# REPORT 5607

## ENGINEERING BULLETIN

### MK 7 MINECRUISER BRAKES

**Service Brake Failure**

MASTER CYLINDER  
MINECRUISER

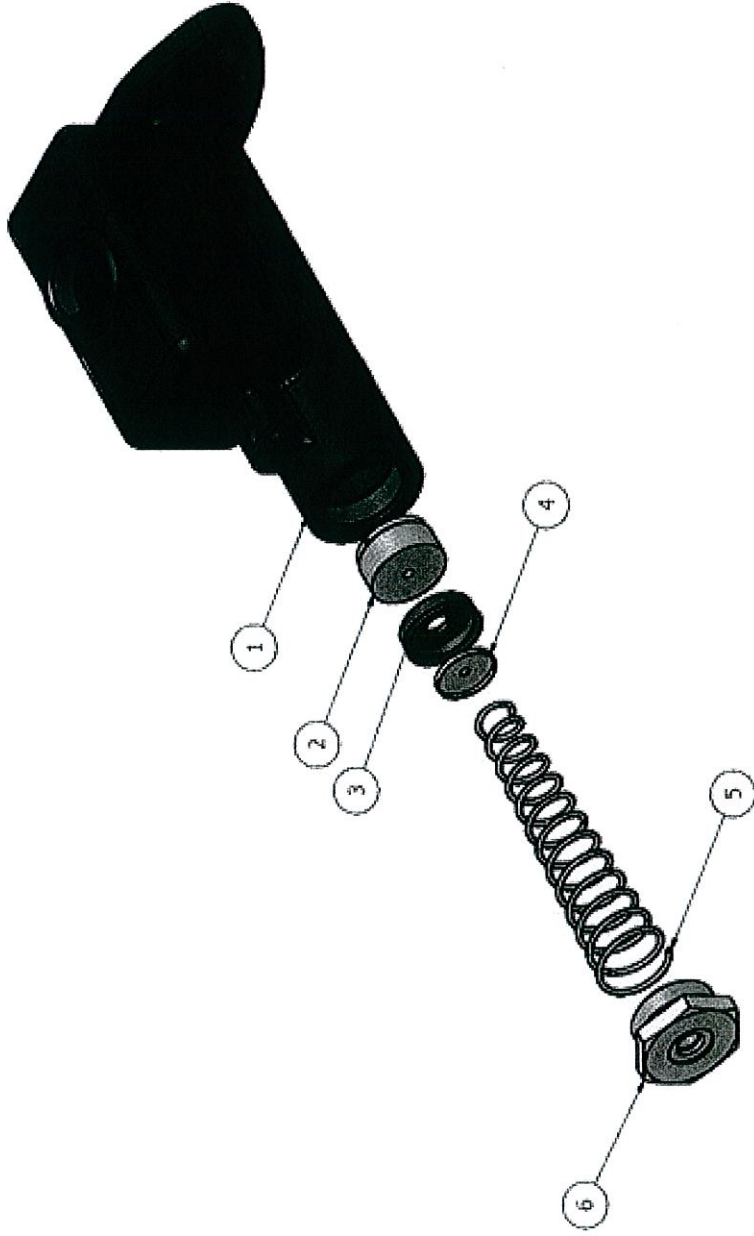
Investigation into separate Mk7 Minecruiser brake issues has determined that a faulty master cylinder hydraulic seal 7-091035-703 (see Appendix A) has caused the service brake to fail. The seal failure has been recorded and shows the service brake pressure decaying over time in response to a steady pedal pressure signal (see appendix B).

The manufacturer of the master cylinder recently changed the supplier of the seal, whereafter failures have occurred. This quality issue will be addressed by the supplier, including an inspection and test program for all future units.

- Ensure that all components are clean.
- Coat Items 2, 3 and 4 with a mineral based hydraulic oil.
- Slide Items 2, 3 and 4 into the bore of the master cylinder.
- Ensure that Item 4 remains inside the cup section of Item 3.
- Use Item 5 and push Items 2, 3 and 4 all the way into the bore.
- Install Item 6 and torque to 75Nm.
- Some caution must be taken with the tension in the spring. Items 5 while assembling Item 6.

**FIGURE 5:** Adjust screws (31) to obtain a distance of  $34 \pm 0.5$  mm between axle machined surface and screw underhead.

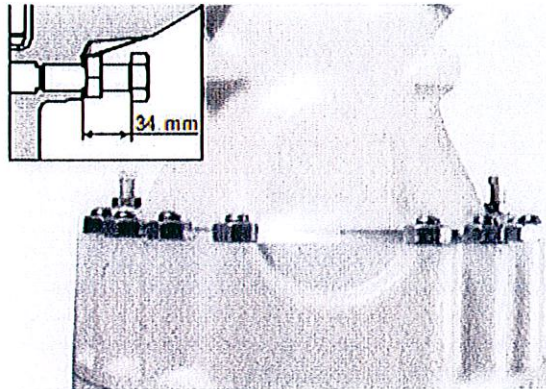
In course of this investigation it was also found that the Brake jacking screws were adjusted incorrectly, causing reduced brake torque on application. Please refer to Appendix C for the correct 34 mm adjustment procedure that will allow full compression of the axle brake.
